Mill Bridge Amphitheater

ADDENDUM #4:

**MILL BRIDGE
AMPHITHEATRE
RENOVATION**

C2.00

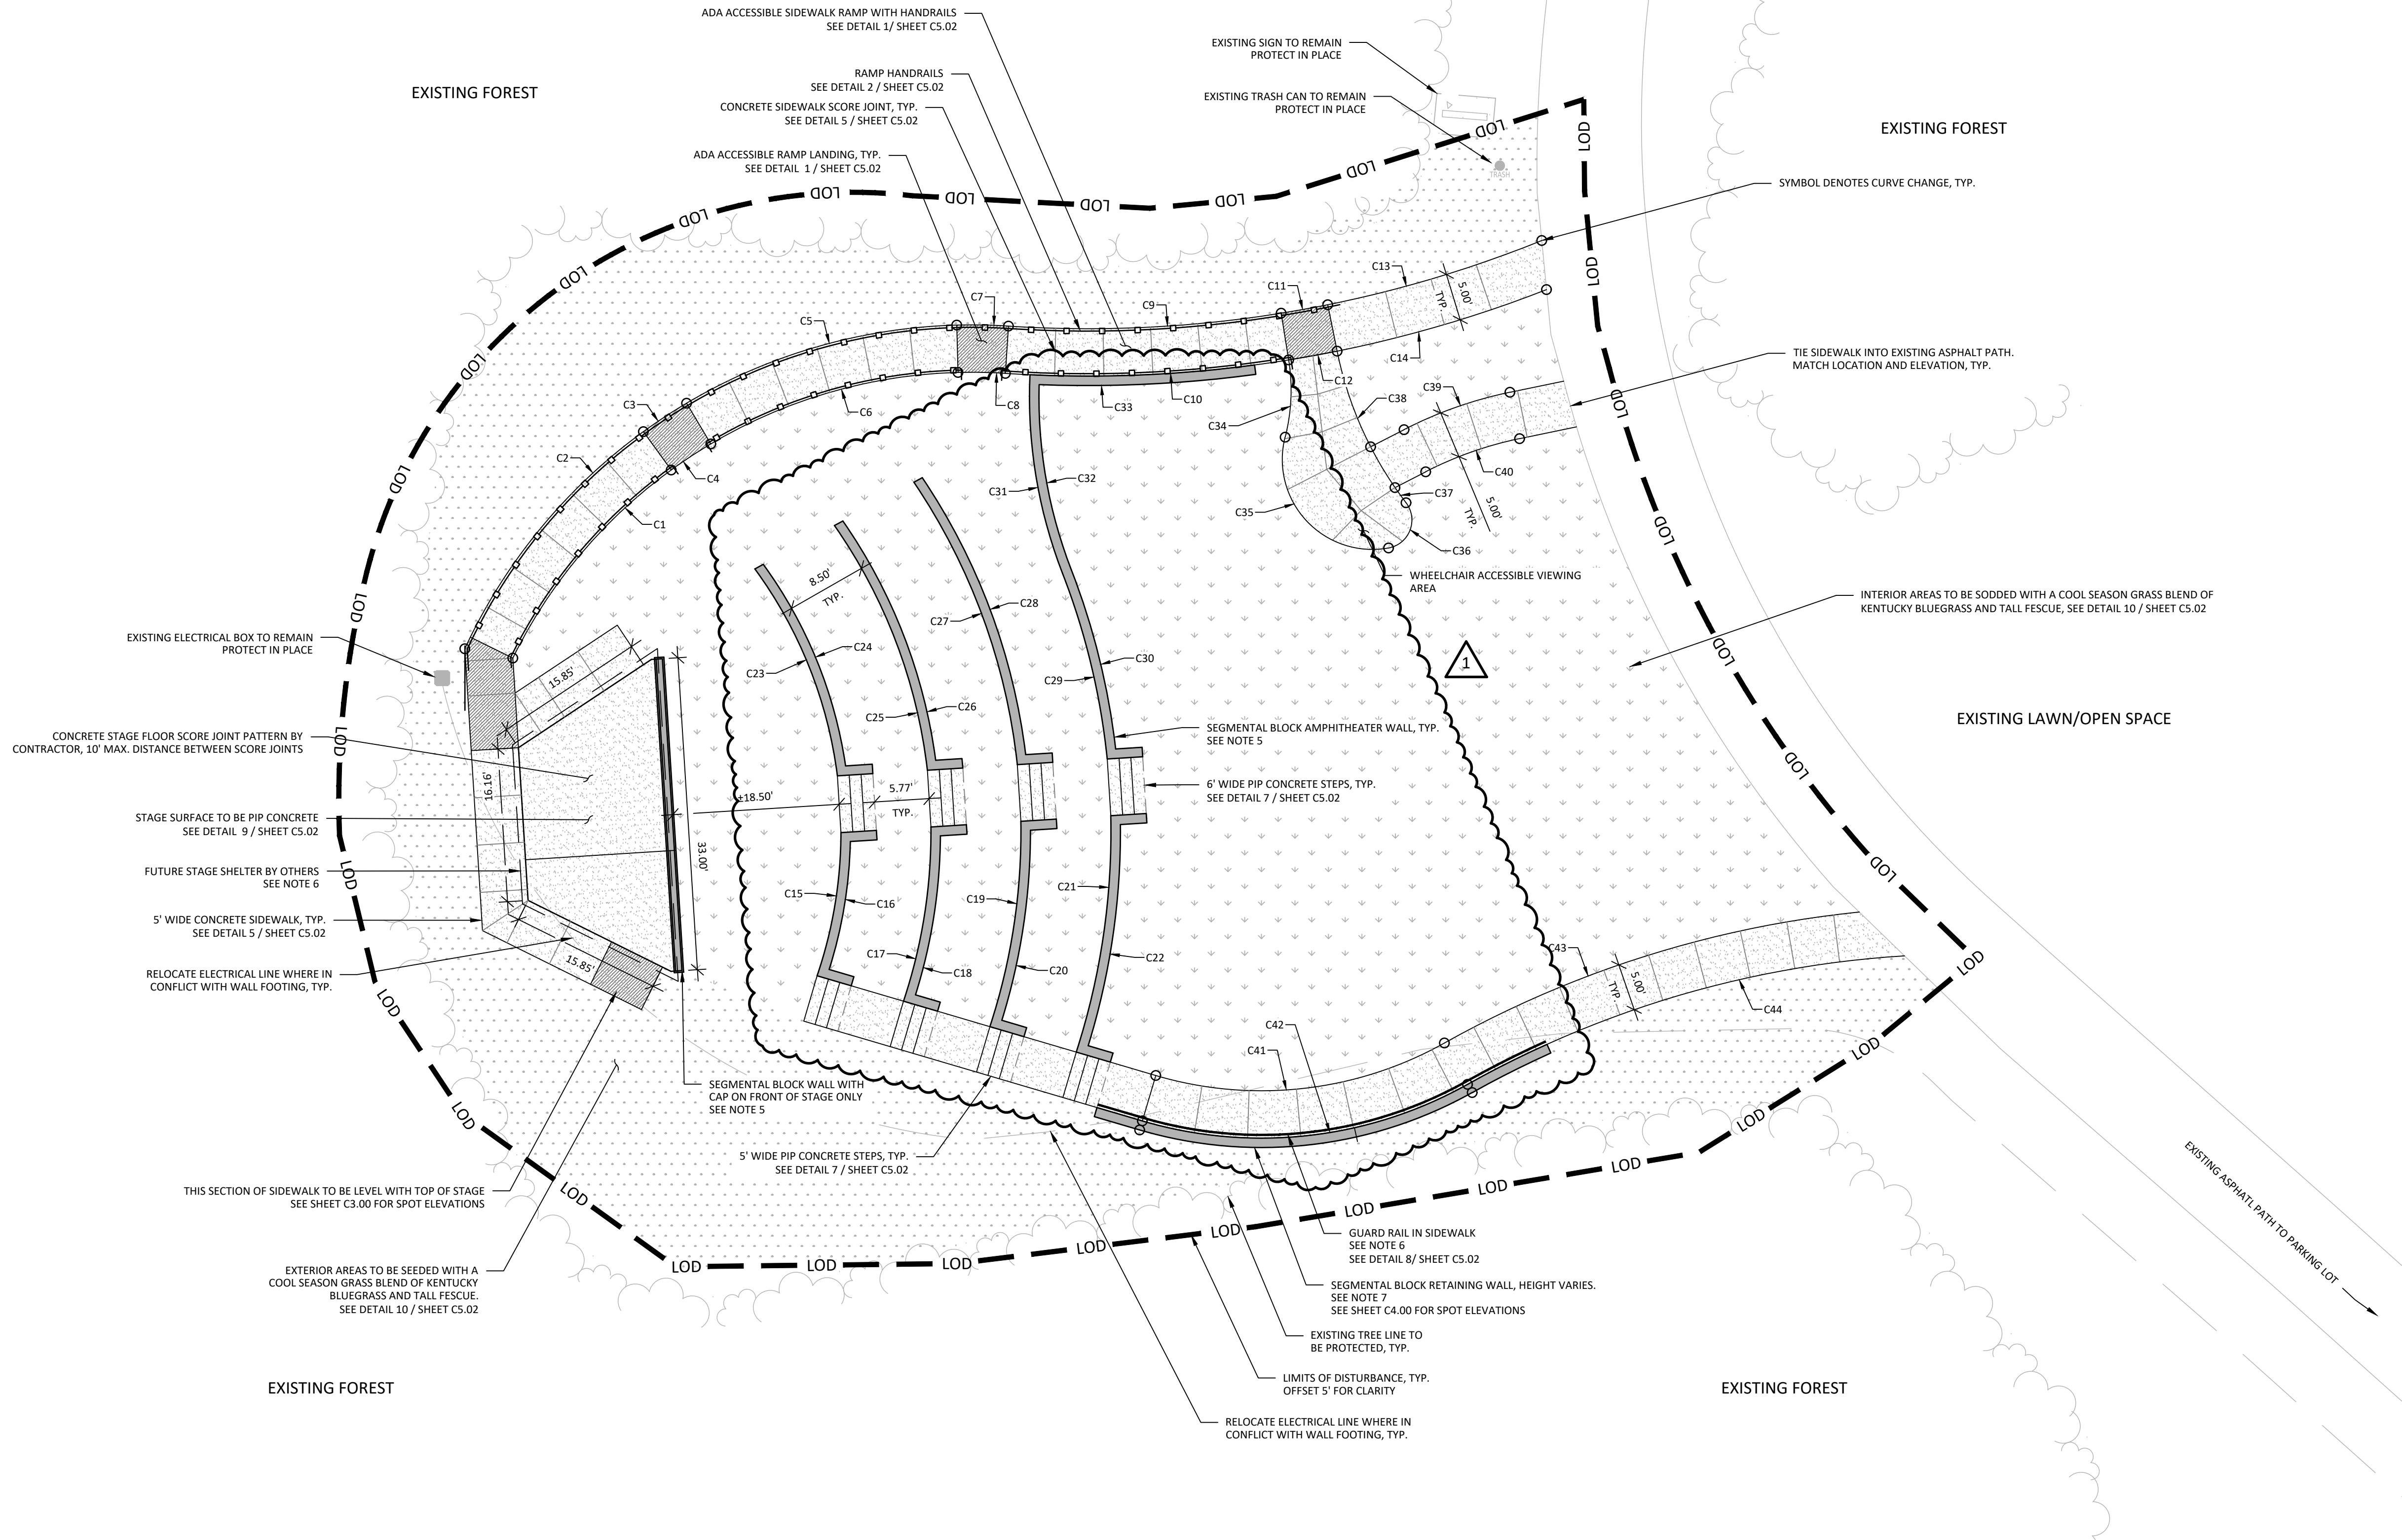
1. Sheets C2.00, C3.00, and C4.00
 - a. The segmental block walls (retaining and seat walls) have been revised from a 18" width to a 12" width due to the Diamond Pro Cap dimensions.

1. On the bid form you have there is 20 SF of block Veneer wall, to what does that refer to?
 1. The Block Veneer Wall refers to the segmental block wall with a cap on the front of the stage, identified on Sheet C2.00, and shown as applied to the face of the stage in Detail 9 on Sheet C5.02.
2. On the site plan it shows that the seating and retaining wall should be 1'6" wide and the Diamond Pro Cap is only available in 12" wide material. I assume that to achieve the 1'6" wide we would have to make a multi wythe wall. Is that correct?
 1. 12" wide is acceptable. Please see the attached revised sheets.
